Addendum 1 to Comments

May 01st, 2024 Committee of Adjustment

1) CAV A/067/2024 PLAN 579 Lot 38 309 Winston Road

Examples of acceptable adjacent "new" home designs:

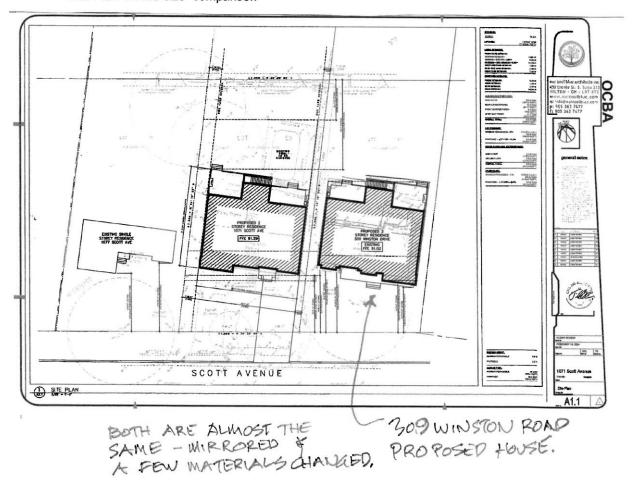
The scale and massing of the proposed house is too large in appearance and should be reconsidered. The surrounding houses, shown in the photographs below are good examples of facades and roof treatments that allow for redevelopment of the neighbourhood with "upscale" homes while reducing the monumental appearance to the street.
